162 Queens Quay East

Schematic Design May 22nd, 2019

162 Queens Quay East
Proponent: 162 Queens Quay GP Inc.
Design Team: Kirkor Architects, Alexander Budrevics
Review Stage: Schematic Design

WATERFRONT TORONTO
DESIGN REVIEW PANEL

GROUND FLOOR PLANS

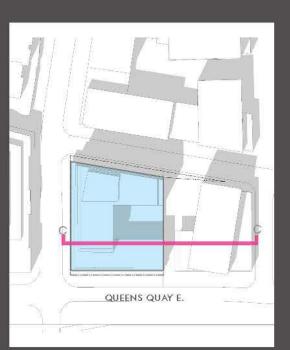
- Show more context program including adjacent streets in all directions, buildings, and public realm

LEVEL 2 PROGRAM

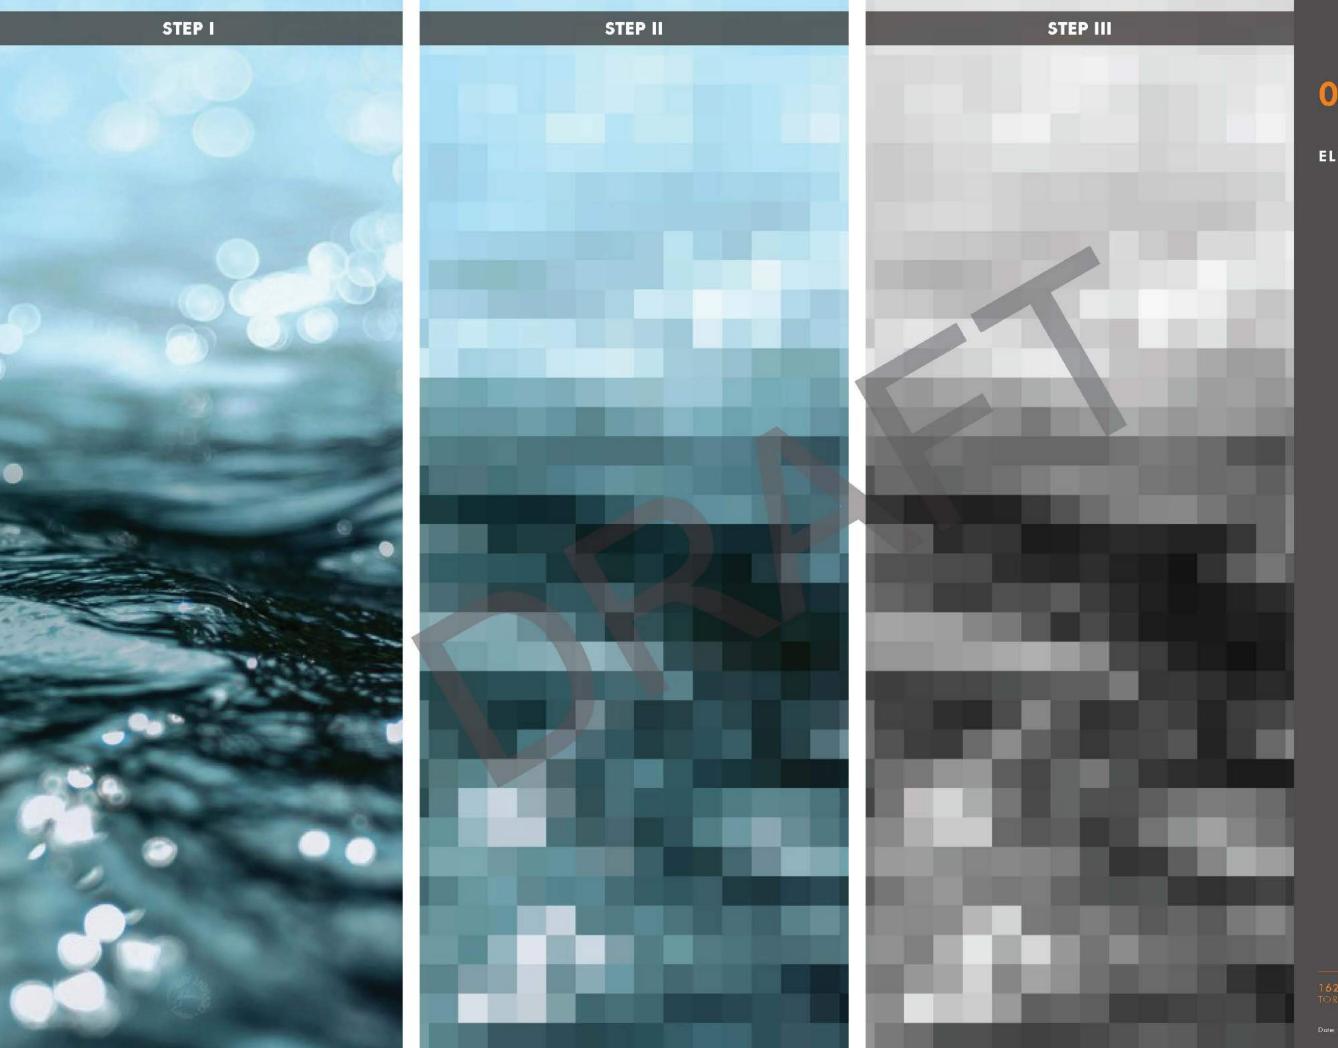
- Consider quality of amenity spaces from perspective of families
- -Due to site size and constraints, encouraged to prioritize quality over quantity for programming

- Area of Refuge designated
- Fitness and yoga facing South towards Queens Quay
- Central Co-working space with skylights creating a bright space
- Study room on the North facing the New Public Road, creating a quiet breakout area

NEW PUBLIC ROAD

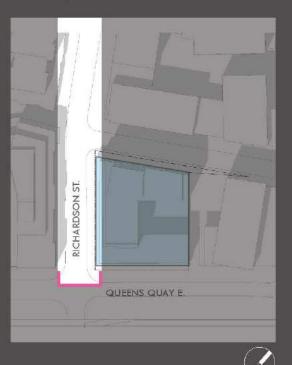
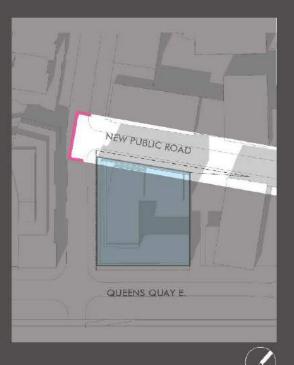
- Clarify design and characteristics of the New Street (in collaboration with the City)
- Include more drawings and information on New Street

- Landscape along New Public Road enhanced
- Elevation along New Public Road enhanced

PARTIAL NORTH ELEVATION

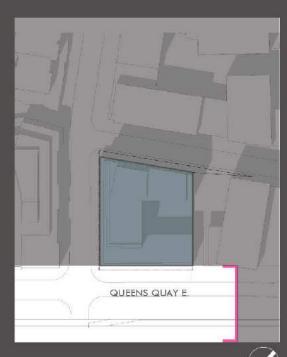
- Clarify East facade relationship with future adjacent development, provide concept and strategy moving forward

There will be a shared parting wall condition. The interim will be a paneled wall, with vertical patterns continuing the prosposed design and colors

CORNER OF RICHARDSON ST. & NEW PUBLIC ROAD

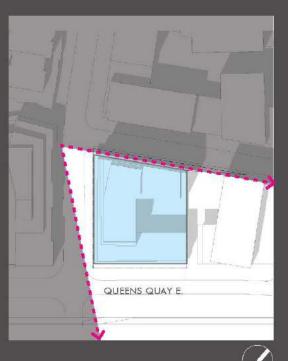
- Define the four corners of the building and take advantage of future Queens Quay Streetscape

North-west corner is cut tack creating a visual connection and openness tetween Richardson St. It the New Public Road

FUTURE PUBLIC ROAD

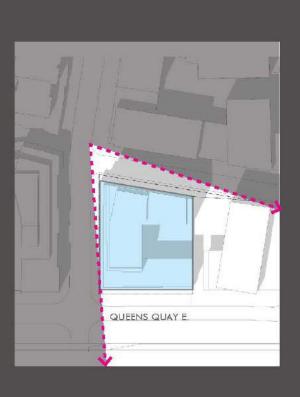
- Clarify design and characteristics of the New Public Road. Include more drawings and infromation

The building elevations
along the New Public Road
have been animated. The
glazing has been extended
throughout the lobby and int
the loading. Trees and green
space has been introduced.
The loading and ramp have
been designed to compliment
the building.

ROOFTOP AMENITY
LEVEL 12

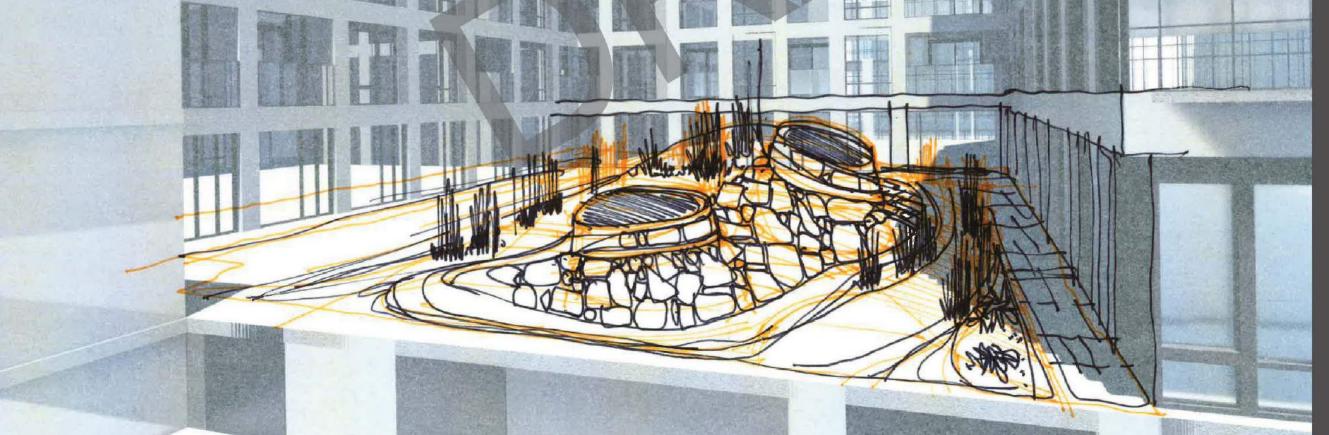
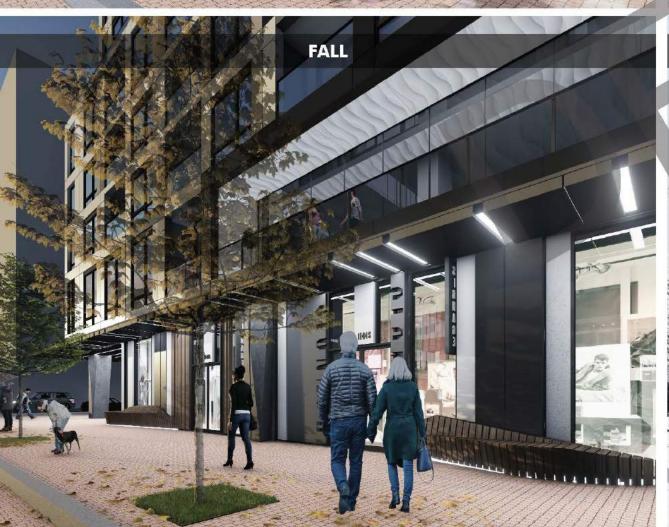
- Consider quality of amenity spaces from perspective of families
- -Due to site size and constraints, encouraged to prioritize quality over quantity for programming

to allow light to penetrate the 2nd floor amenity co-working space

SPRING

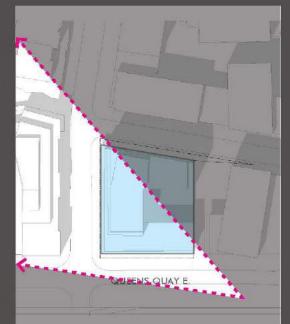
- Consider year round use and quality of outdoor amenity spaces
- Consider how retail at grade can be improved to reinforce retail community along Queens Quay

- Studied the conditions along Queens Quay E. retail street during all seasons
- The retail has been designed as a continuously variating frontage, giving a human and inviting scale along Queens Quay E.
